UNITED STATES PATENT AND TRADEMARK OFFICE

Office Action Summary	Application No. 10/734,322	Applicant(s) HARRIS ET AL.	
	Examiner Jack W. Lavinder	Art Unit 3677

DETAILED ACTION

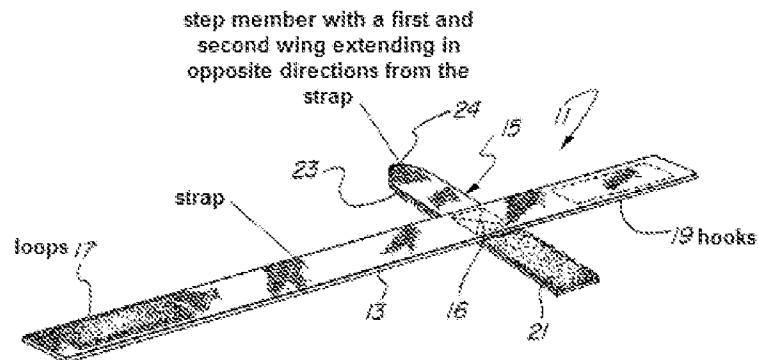
Claims 1-4, 11-12, 14, 19, 20, 23-27, 29-30, 32, 35 and 57-59 have been rejected under 35 U.S.C. 102(b) as being anticipated by Uso, Jr., 4759963. Uso, Jr. discloses a device capable of being used to dampen vibrations on a human body part (see annotated figure, column 2, lines 9-15).

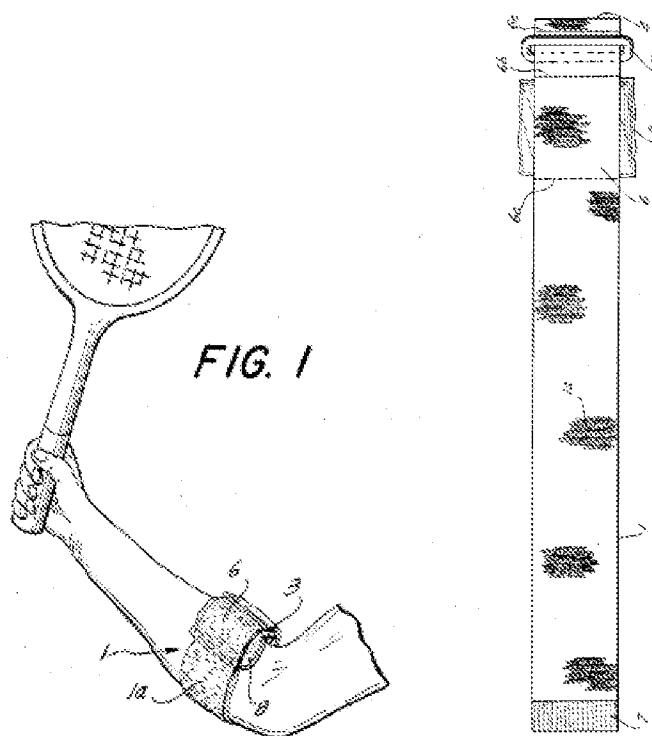
Claims 36, 39, 40, 46, 48, and 51-55 have been rejected under 35 U.S.C. 102(b) as being anticipated by Johnson, Jr., 4628918.

Regarding claims 36, 39, 40, 46, 48, and 51-55, Johnson, Jr. discloses a method for dampening vibration of soft tissue of a human wearer's body part comprising providing a stretchable strap with a step member with a first and second wing and wrapping the strap, under tension, around the body part.
